PCI-SIG ENGINEERING CHANGE NOTICE

TITLE:	Separate Refclk Independent SSC Architecture (SRIS) JTOL and SSC Profile Requirements
DATE:	Updated 31 March 2014
AFFECTED DOCUMENT:	Separate Refclk Independent SSC Architecture (SRIS) ECN, PCI Express Base Spec. Rev 3.1
SPONSOR:	Intel

Modifies specifications to provide revised JTOL curve for SRIS mode and provides additional frequency domain constraint of SSC profile jitter on reference clocks.

Figure 4-x0: Swept Sj Mask

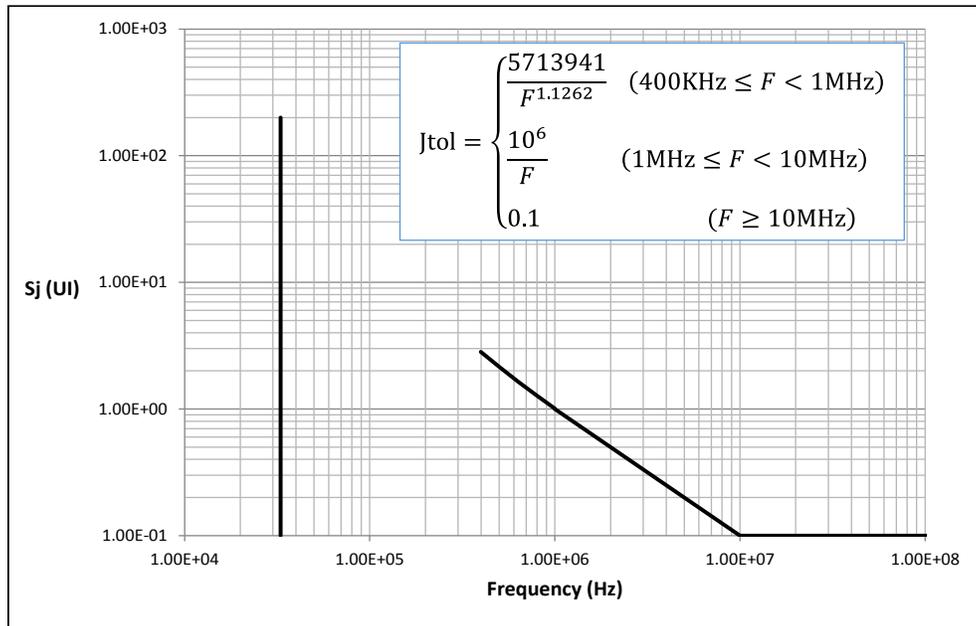
- ❑ The DUT shall be driven with an independent SSC modulated reference clock for all testing. SSC shall meet the frequency limits and maximum deviation range defined in table 4-34.
- ❑ The generator shall be driven with an independent SSC modulated reference clock for the stressed voltage test. SSC shall have a triangular profile and meet the frequency limits and maximum deviation range defined in table 4-34.
- ❑ The generator shall provide a 33 kHz Sj tone with 25 ns peak to peak amplitude during the stressed eye test.
- ❑ The generator shall transmit with a nominal unit interval of 125.3125 ps during the stressed eye test.
- ❑ Sj shall be swept over the range given by equation 4-x0 and shown in Figure 4-x0 during the stressed eye test:

$$\text{Sj in Unit Intervals} = \begin{cases} \frac{5713941}{F^{1.1262}} & (400 \text{ KHz} \leq F < 1 \text{ MHz}) \\ \frac{10^6}{F} & (1 \text{ MHz} \leq F < 10 \text{ MHz}) \\ 0.1 & (F \geq 10 \text{ MHz}) \end{cases}$$

Equation 4-x0 SRIS JTOL Curve

Figure 4-x1: Limits for phase jitter from the Reference Clock

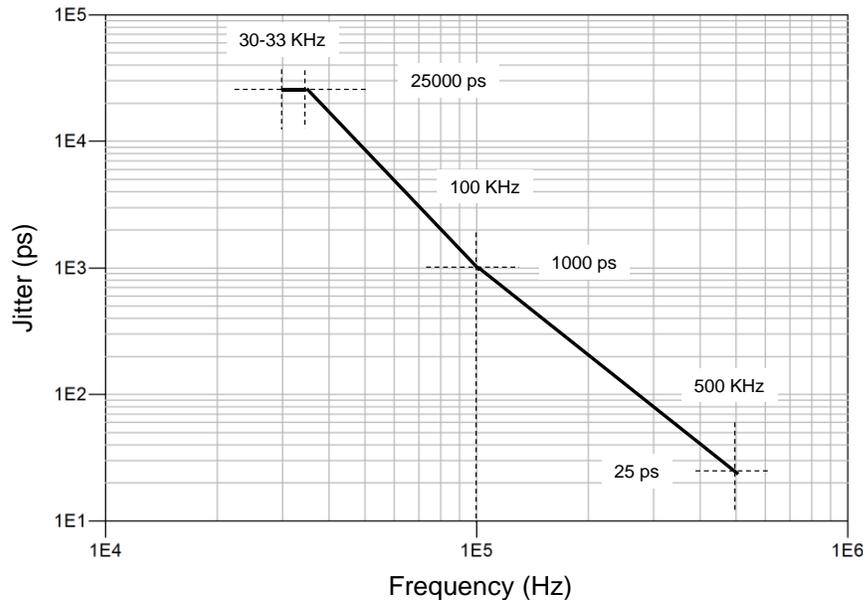
The tolerance for the Refclk is 100 MHz \pm 300 ppm, where this number is defined with spread spectrum clocking (SSC) turned off. SSC may be implemented as a method of reducing EMI. The Refclk rate for a single source may be modulated from +0 to -5000 ppm of the nominal data rate frequency, at a modulation rate lying within a 30 kHz – 33 kHz range. The maximum rate of change of the frequency on a reference clock with SSC active is 1250 ppm/us. Refclks that operate with SSC need to meet an additional frequency dependent phase jitter limit at low frequency. The data points in Table 0-x1 are used to construct a piecewise linear graph from 30 kHz to 500 kHz and the unfiltered phase jitter of the reference clock in the frequency domain must fall below this graph as shown in Figure 4-x1.

Frequency	Maximum Peak to Peak Phase Jitter (ps)
30 kHz - 33 kHz	25000
100 kHz	1000
500 kHz	25

Figure 4-9x2: Informative CDR Jitter Transfer Function for the Separate Refclk With Independent SSC (SRIS) Architecture at 8.0 GT/s

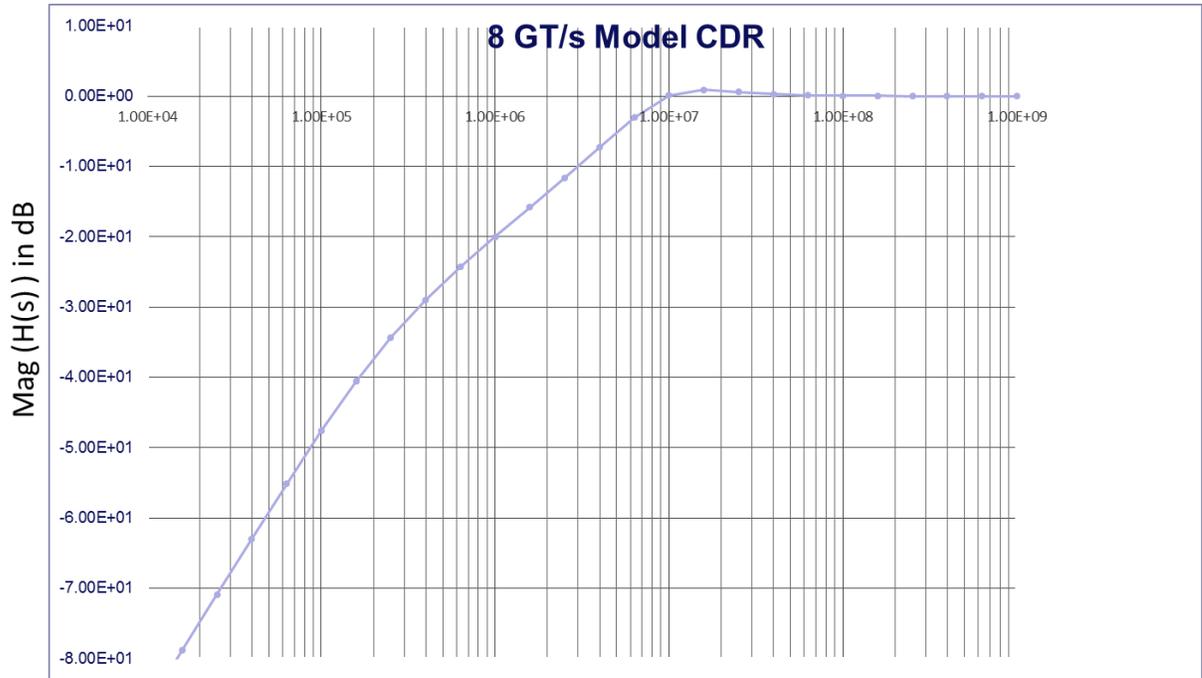
pass the jitter mask (Figure 4-74). For the separate Refclk with independent SSC architecture, the CDR needs to have increased rejection at low frequency to handle the extra phase drift due to independent SSC. The new behavioral CDR jitter transfer function is shown in Figure 4-9x2 and Equation 4.3.8. The model CDR jitter transfer function is a continuous approximation of the inverse of the jitter tolerance curve for SRIS mode. The stressed jitter test is also modified to account for the requirement that the CDR can reject jitter from two separate reference clocks with SSC. Other test parameters and requirements such as transmitter jitters (Table 4-19) and the receive stressed voltage eye (Table 4-22) remain unchanged.

$$H(s) = \frac{s^2}{s^2 + sA + B} \cdot \frac{s^2 + 2\zeta_2\omega_0s + \omega_0^2}{s^2 + 2\zeta_1\omega_0s + \omega_0^2} \quad \text{Equation 4.3.8}$$

$$\zeta_1 = \frac{1}{\sqrt{2}}; \zeta_2 = 1; \omega_0 = 10^7 \times 2\pi$$

$$A = 10^7 \times 2\pi; B = 2.2 \times 10^{12} \times (2\pi)^2$$
